City of Kerrville Planning & Zoning Commission Agenda

Thursday, January 15, 2009, 4:30 p.m.

AGENDA ITEM: 4B **FOR AGENDA OF:** January 15, 2009

DESCRIPTION: Replat: Kerrville Meadows – A replat of Lot 3, Block 1, Kerrville Meadows, located at 2330 Junction Highway. Zoned: W-2. (File No. 2008-69)

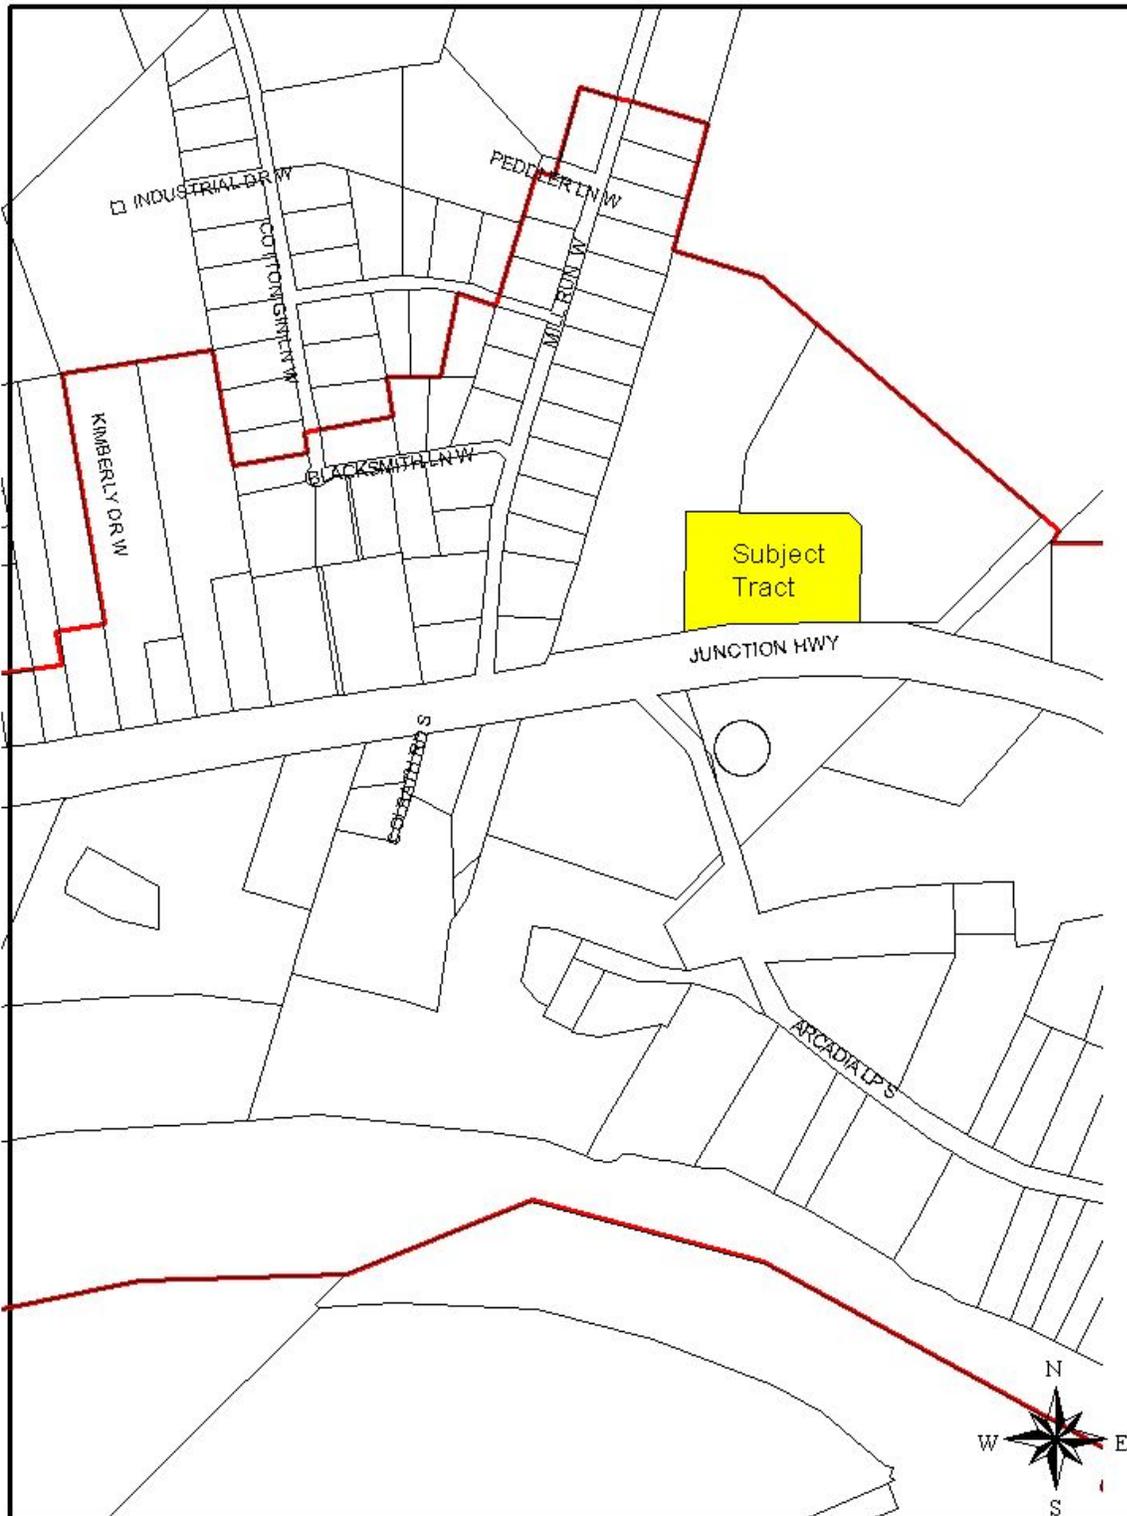
- Replat proposes to divide Lot 3 into two (2) lots.
- TxDOT approval required for access to Junction Highway (SH 27).
- Municipal utilities exist to serve this tract.
- Approval of the replat does not constitute construction approval, individual permits will be required prior to development.
- Prior to final plat acceptance engineering plans must be submitted and approved by the City Engineer, if necessary.

1. Open the public hearing and receive comments, and
2. Approve the replat subject to the following conditions;
 - a. Show all existing and proposed easements on the final plat with dimensions and labeled by type to include franchise utilities. Label existing easements as 'Existing' and provide recording information. Identify proposed easements by stating dedication method within parenthesis, ex. (By Plat).

- b. The 12-foot wide emergency access easement shown relocated on the replat should be shown as abandoned and relocated by plat. Also, verify plat records reference.

- c. Show existing sanitary sewer easement along common lot line.
- d. Show 'No Access Line' along SH 27, access will be at a 45-foot point centered on the existing emergency access easement. Access to Lots 3R and 4 will be shared.

EXHIBIT "A"

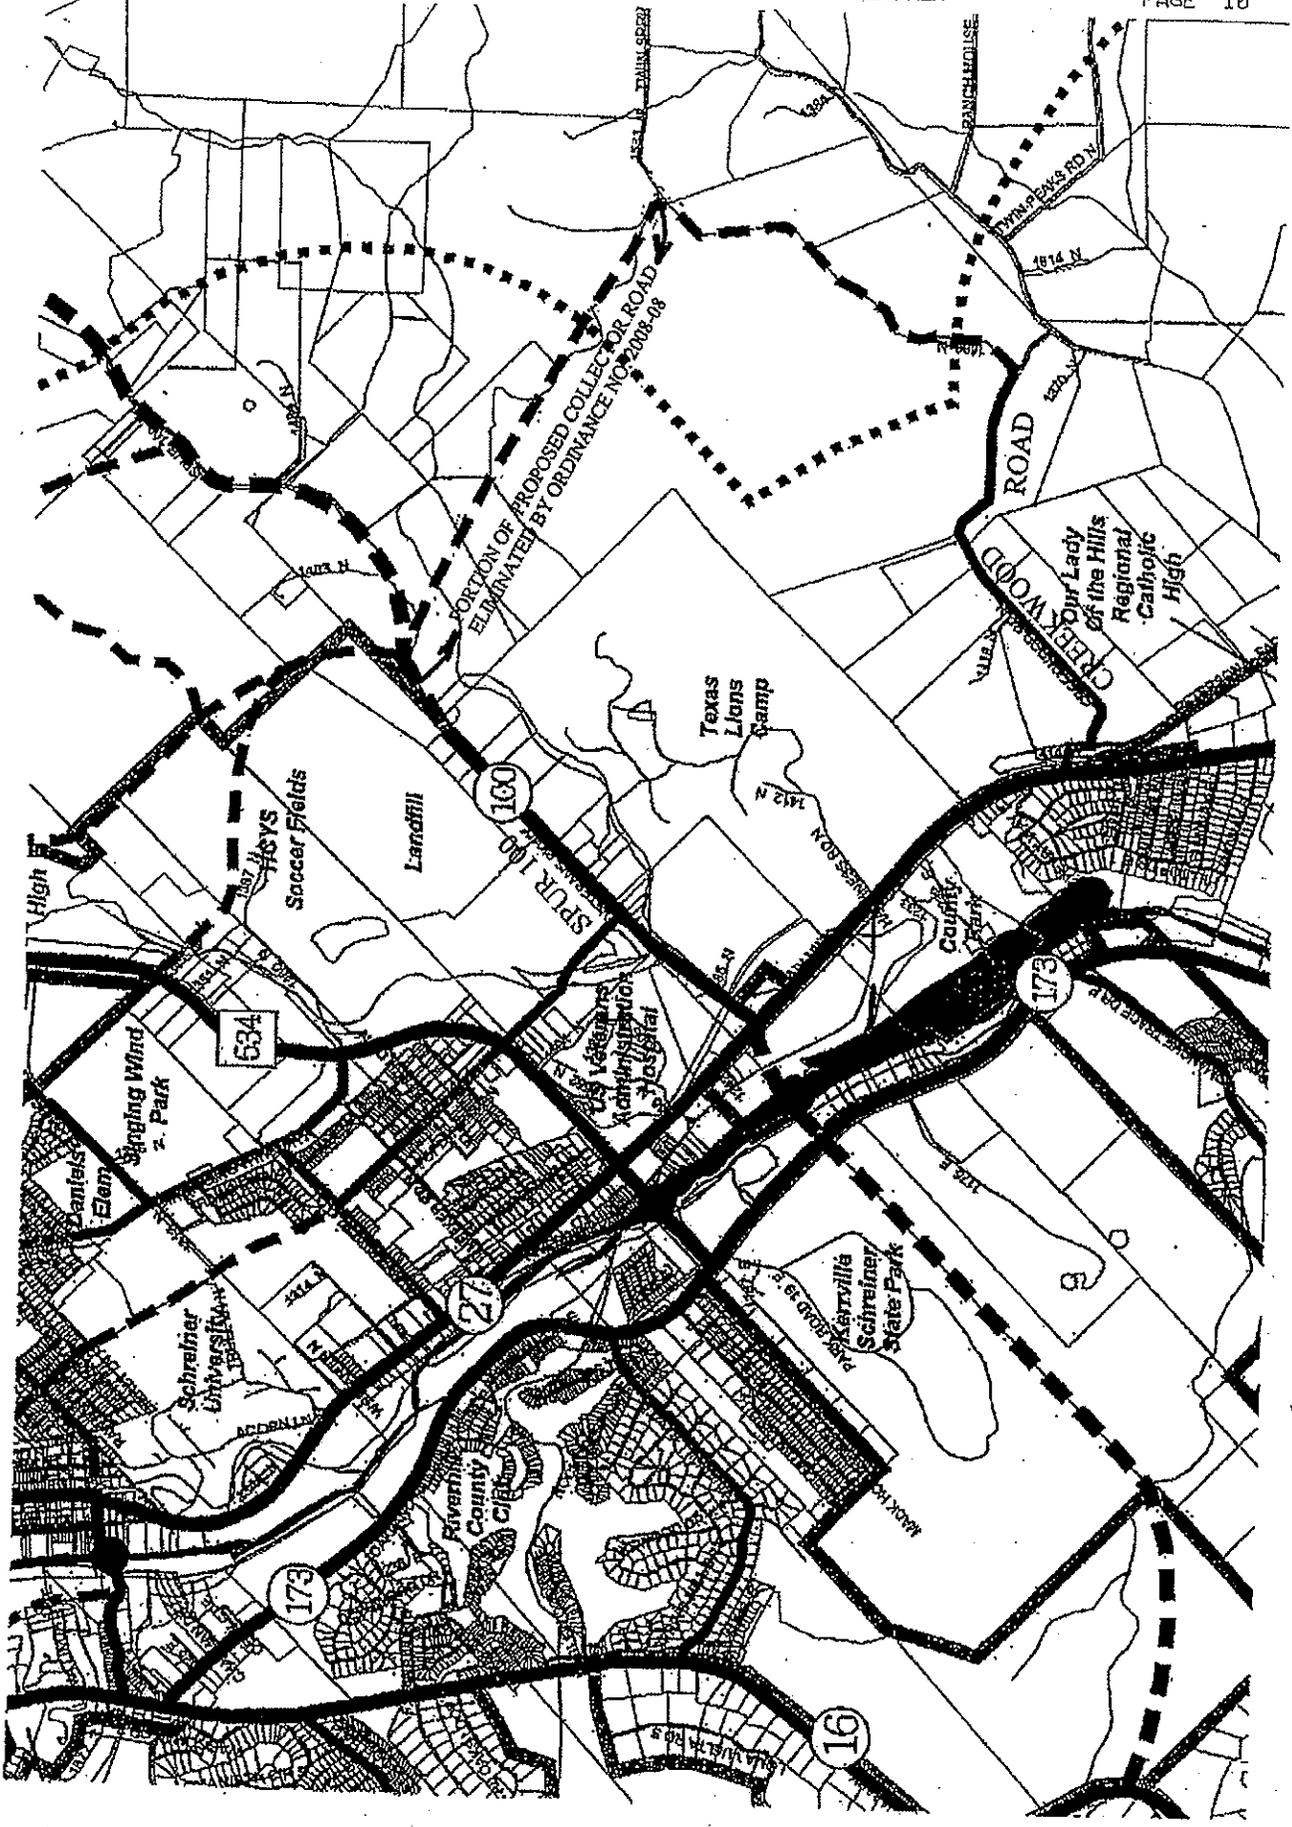
The Thoroughfare Plan was brought to our attention through a replat of a lot in Twin Springs Ranch II. The plan showed a proposed collector road connecting Spur 100 (a public road) to Creekwood Road (a private road). On March 25, 2008 the Kerrville City Council passed an ordinance (No. 2008-08) which amended the Thoroughfare Plan by removing a portion of the proposed collector road from Spur 100 to the Creekwood boundary (see Exhibit "A"). My clients are asking the planning commission and council to remove the remainder of the proposed collector road to Creekwood Road (see Exhibit "b").

The proposed collector road between Spur 100 and Creekwood Road accomplishes neither objective. The proposed location crosses properties which have already been developed as large acreage tracts. These subdivisions, known as Twin Springs Ranch and Creekwood are both private developments served by private roads. Twin Springs Ranch is a gated community. Both of these subdivision restrict tract size to a minimum of 25 acres. This large tract size will reduce the density of the area. Because of the topography it is not economically feasible to build a road. Also note that the grade of the road would greatly exceed Kerrville's 12% maximum road grade.

Accompanying this memo are Resolutions by the Creekwood I and Creedwood II Land Owners Associations. Mr. Moser, Mr. Stewart, and Mr. Sutherlin respectfully request the City of Kerrville Planning and Zoning Commission and City Council to amend the Thoroughfare Plan by eliminating the remainder of the proposed collector road between Spur 100 and Creekwood Road. They will be at your meeting to offer information and/or answer questions.
